MURRAY CITY PLANNING COMMISSION

NOTICE OF MEETING AND AGENDA

December 07, 2023

4. **Take 5 Murray - 696 West 5300 South**

Figure 1: Site Plan

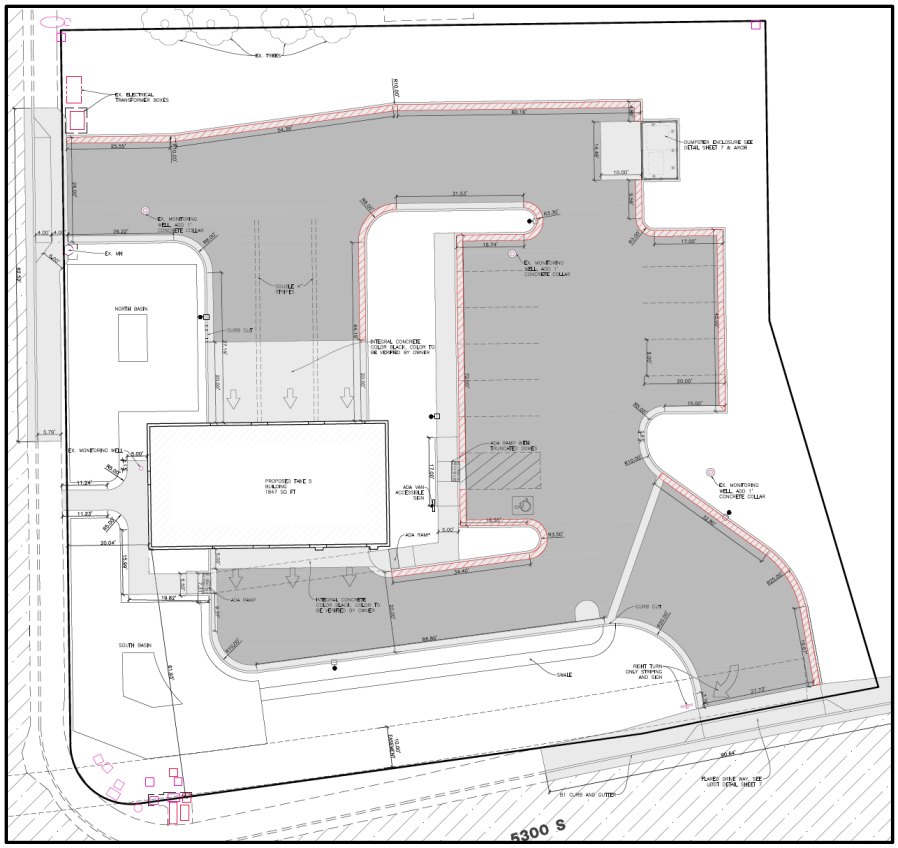
Entrance to the site will be accessed from Murray Blvd. and 5300 South. Full access from Murray Blvd.is allowed. Egress onto 5300 South is preferred to be a right-hand turn only and the applicant is proposing to post signage indicating right-hand turn only. Both drive approaches must be a minimum of 25' wide and a maximum of 50' wide to meet the access requirements of section 17.72.100.C The site plan shows the Murray Blvd. access to be 26' wide The 5300 South drive access is 27.73' wide . 5300 South Street is controlled by UDOT and the applicant will need to coordinate the access with UDOT. The customer vehicles enter the bays from the north and exit at the south of the building and can either wind back north through the parking lot to exit onto Murray Blvd. or make a right-hand turn onto 5300 South. A 5' wide sidewalk connection is provided from Murray Blvd. into the site and extends through the parking area. Staff has no concerns with the access and circulation for this proposal.

Chapter 17.156.090 of the Murray City Land Use Ordinance requires 1 parking space for each 250 ft^2 of net usable office space and 1 parking space for every 750 ft^2 of net storage/shop floor area, and 3 spaces per service bay. The office space is calculated to be around 84 ft^2 which will require 1 space, the shop/storage space is 495 ft^2 which will require 2 stalls, and the 3 bays require 9 spaces. Ninety-degree parking stalls are required to be 9'X18' with 24' of aisle space. The total required parking for the site is 12 spaces. The total parking shown on the site plan is 12 stalls including one ADA van-accessible stall. Staff has no concern with parking.

Section 17.156.100 requires ten feet (10') of landscaping along all frontage areas and ten feet (10') of buffer landscaping adjacent to residential zoning in addition to the required buffer wall. Additionally, landscaping must cover at least 10 percent (10%) of the development site. The landscape plan shows a range of 10' to 13' frontage landscaping along Murray Blvd. and a range of 10 'to 30' along 5300 South frontage. There is a minimum 10' landscaping strip on both the north and east boundary lines. Within the frontage landscape areas, ground cover is required to provide fifty percent (50%) bed coverage at time of planting. Ground cover includes grasses, shrubs and other low-growing vegetation, but does not include trees. Landscaping coverage calculations are not provided in the landscape plan and will need to meet the minimum 10% requirement.

The trees proposed within the frontage area are 1.5"caliper size. A minimum 2.0" caliper is required as measured at 12 inches above the soil surface of the plant's root ball and shall not require a support stake to remain upright. The proposed landscape plan meets the minimum number of trees and shrubs, however; Staff recommends the landscape plan be updated to show the required trees within the front setback area be of 2.0" caliper and verification that the front setback area be planted with living ground cover to meet the minimum of fifty percent (50%) of landscape bed coverage at the time of planting.

7. A solid six-foot (6') masonry wall is required to be installed along the east boundary line.
8. The landscape plan be updated to show the required trees within the front setback area be of 2.0" caliper and the front setback area to be planted with living ground cover to meet a minimum of fifty percent (50%) of landscape bed coverage at the time of planting. The updated plans must meet the required minimum 10% landscaping coverage for the site.

10. Submit updated civil and landscape plans to match the 11/30/23 Site Plan.
